REQUEST

Current Zoning: MUDD-O (mixed-use development district, optional) CAC-2 (community activity center – 2), and N2-C (neighborhood 2 – C)
Proposed Zoning: UE(EX) (uptown edge, exception)

The petition proposes to allow for the redevelopment and expansion of the existing Panthers’ Practice Facilities and associated accessory uses.

STAFF RECOMMENDATION

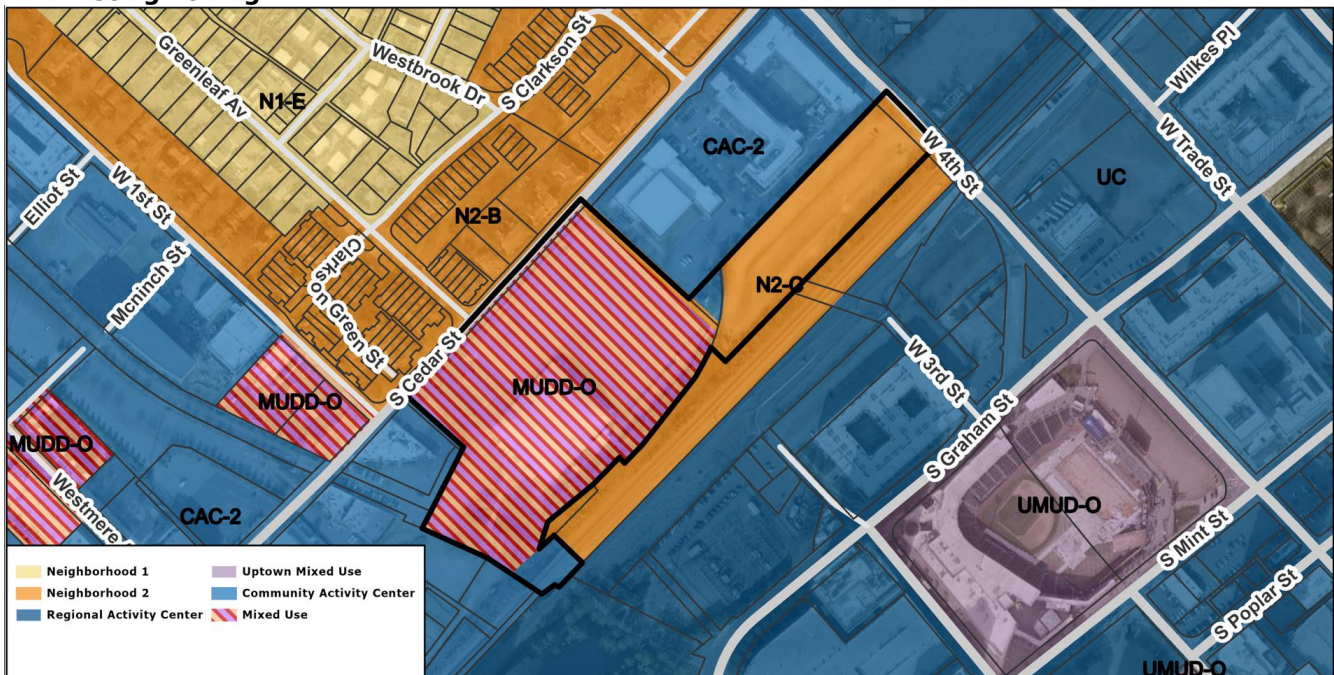
- Proposes two development areas:
 - Development Area A may be developed with practice and training facilities, fieldhouse facilities, indoor seating for sports events and performances, up to 5,000 seats for outdoor uses, sports operations, reception facility uses, periodic outdoor markets, mobile food and retail vendor uses, public transit facility uses to accommodate the future rail right-of-way, and all accessory uses permitted in the UE district.

- Proposes a maximum building height of ~~70' 80'~~ for Development Area A.
 - Development Area B may be developed with all uses permitted by-right and under prescribed conditions in the UE district.

- Proposes a maximum building height of 150' for Development Area B.
- Notes that this rezoning site may be viewed as a planned/unified development with the stadium property.

- Notes that the shared-use pedestrian path from Graham Street along Development Area A that extends to the future Irwin Creek Greenway shall not be a frontage and may be closed during events and sequentially shall not be subject to UDO regulations applicable to frontage types until the proposed Cycle Track improvements across adjacent parcels are completed. The petitioner may seek a text amendment ensuring that such frontage standards do not apply to the site development which if approved would be applicable to this rezoning. However, if it in the future it is determined that the pedestrian connection on the site is a frontage then applicable EX provisions setout regarding build-to-zones, build-to-percentages, and the like are included in this conditional plan.

- Notes that any building 100' or greater from a frontage is not subject to regulations within the UDO which are applicable to frontage types.
